Your ref: SSD 9409987  
Our ref: 12524108

**SSD-9409987 - Response to IPC Request for Information (12524108)**

GHD provides the following responses on the matters raised in correspondence from the Independent Planning Commission dated 6 December 2024 (reference 12524108).

Figure 1 Process water treatment process showing proposed discharge to sewer

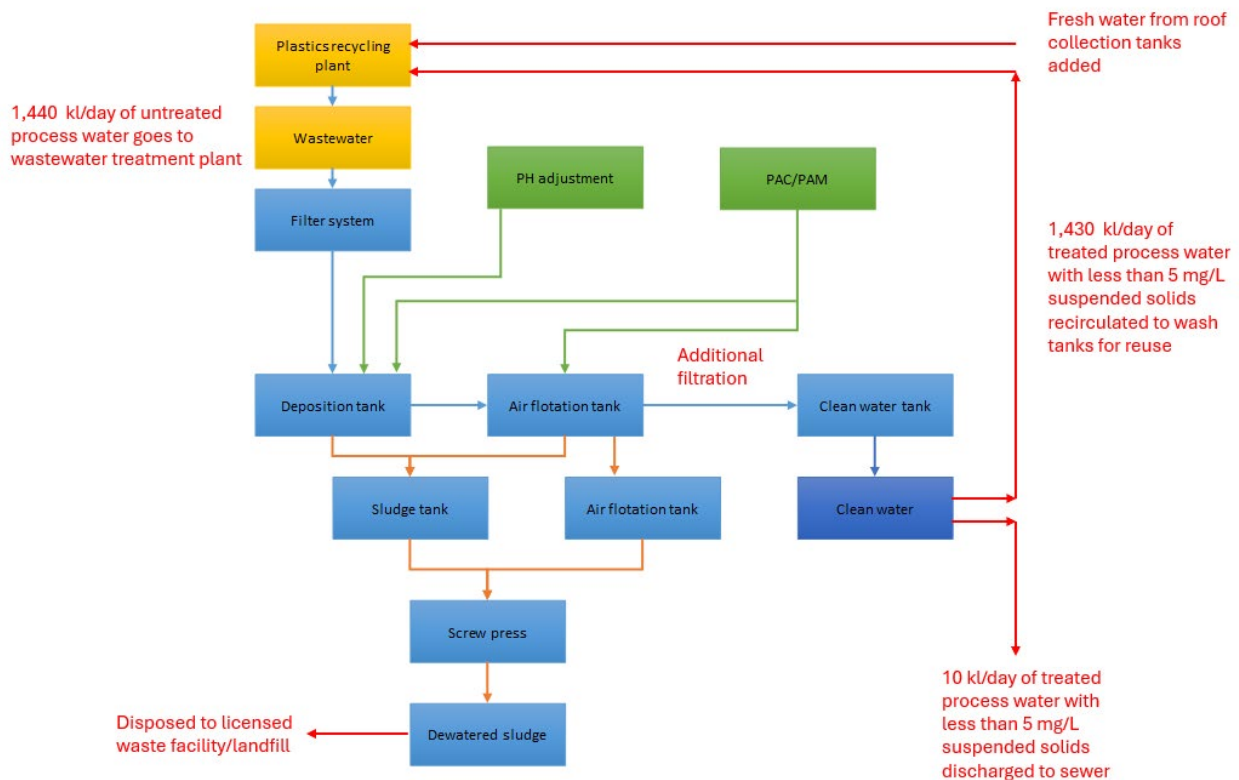
*The Applicant advised the Commission that the Project could effectively operate with nil discharge of process water (Applicant meeting transcript pg. 12). Please provide further information on the proposed process water discharge including whether the proposed 10kl/day is required.*

The process water flow diagram (Figure 7.3 from the EIS) is provided overpage. Additional arrows and notes have been added to illustrate where in the process that the process water (up to 10 kl/day) would be discharged to sewer. Approximately 1,440 kl/day of process water would pass through the wastewater treatment plant, and up to 1,430 kl/day of this water (99 %) would be continuously recirculated.

The main reason for discharging water would be to prevent salts from building up in the process water, which would depend upon whether the containers that are provided from the material recovery facilities are fully washed, and whether there are any salty residues. Fresh water from rainwater tanks would be used to make up for the losses from sewer discharge, evaporation and carry through on the cleaned product.

If salt levels remain low, then there would be no need to discharge any process water to sewer, and it would effectively be a zero-discharge facility. Any discharges to sewer would comply with Council's Trade Waste Agreement levels, and as highlighted in GHD's recent response to the IPC (25 November 2024, Submission on behalf of the proponent: Plasrefine Recycling), the suspended solids concentrations would not exceed 5 mg/l.

Figure 2 Access road options

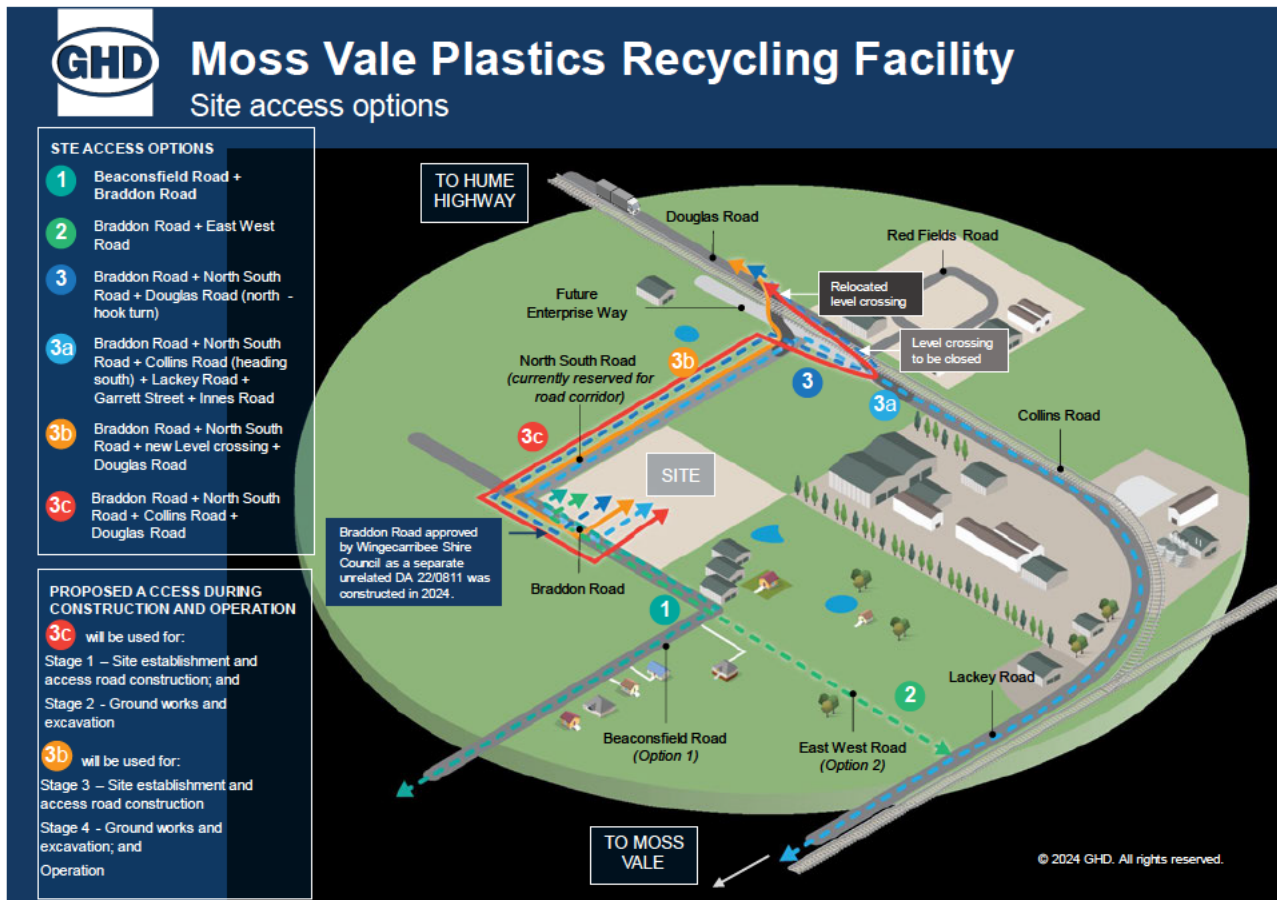
a. clarification of the access route and access point for construction vehicles (both heavy and light vehicles) during:

i. the earthworks phase of construction; and

ii. prior to the north-south access road being constructed, including in the scenario that the relocation of the level crossing and/or the works on Collins Road and Douglas Road are being undertaken simultaneously with earthworks;

The Amendment Report nominates that the access route for construction vehicles is the new North South Road, connecting with the recently constructed Braddon Road in the south. This route is identified as 3B on Figure 2 and will ultimately be constructed to meet the standard of a collector road, as identified in Council's Moss Vale Enterprise Corridor Development Control Plan 2008. This is the nominated route for both heavy and light vehicles.

For the earthworks phase of the project, referred to in the Amendment Report as Stage 1 – Site establishment and Stage 2 – Groundworks and excavation, the North South Road would initially be constructed as a temporary access road and Route 3C used. This is the nominated route for both heavy and light vehicles.

Stage 3 and Stage 4 would not commence until the new level crossing is operational which enables Route 3B to be used to complete construction of the project and for the operational stage.

Figure 3 Level of enclosure of equipment

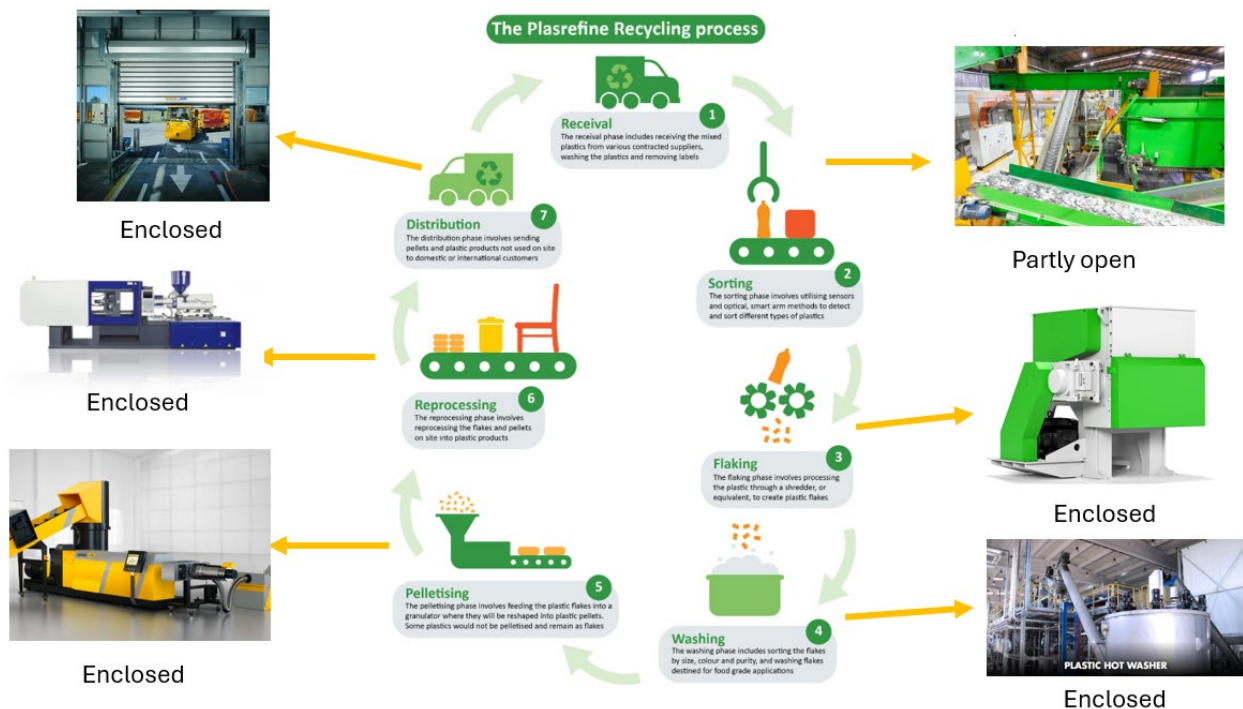
Noting the Applicant's response on Day 3 of the Public Meeting, please provide a visual representation identifying points in the recycling process, from the unloading of feedstock to the loading of the finished products (either in pellet/flake form or as remanufactured products). The representation must clearly demonstrate where in the process plastic materials are not fully enclosed and/or encapsulated.

A diagram of the process that appears in the EIS (Figure 7-6) has been adjusted to show photos of the various items of processing equipment and their degree of enclosure. Specific processing equipment is still to be selected with the final equipment selection to take place during the detailed design process, which typically follows the planning approval stage.

Notwithstanding the final equipment selection, all key steps of the process are enclosed with the exception of the sorting phase, which is partly open due to the need for operators to see what items are on the conveyors and ensure that no unsuitable items are there.
